Service Bulletin

311

MODEL: DNCB CC Coke Venders

SUBJECT: Installation
Maka Validator
Model: NB15A

Bottom
Fig. 1

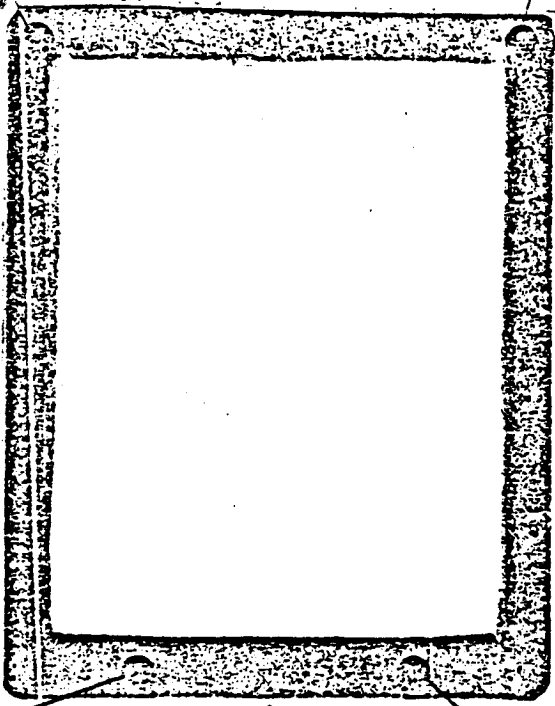
1	A432,010,010.03	Validator Mounting Ring (Fig. 1)
4	900,800,500.01	Keps Nut 8-32
1	B432,050,470.03	POS Window Retainer (Fig. 2)

- DO THIS:
1. Remove the Validator cover plate from the vender's Main Door.
 - 2a. Remove the two (2) Coin Insert Retainers - Fig. 3.
 - b. Replace these with POS Window Retainer - Fig. 2.
 - 3a. Some Venders will have a Coin Insert Retainer which is almost identical to Fig. 2.
 - b. If the Vender's Serial Number is not 0001-2967 or higher, replace the Retainer.
 - 4a. Install the Validator Mounting Ring (bottom down - Fig. 1) in the opening from which the Validator Cover Plate was removed.
 - b. Once inserted, install ~~two~~ (4) keps nuts (as spacers) on bottom studs. *For 4*
 - 5a. From the rear of the Main Door, align the nose piece of the Validator with the Validator opening, and push through.
 - b. Align Validator holes with Mounting Ring Studs and secure Validator with Keps Nuts.
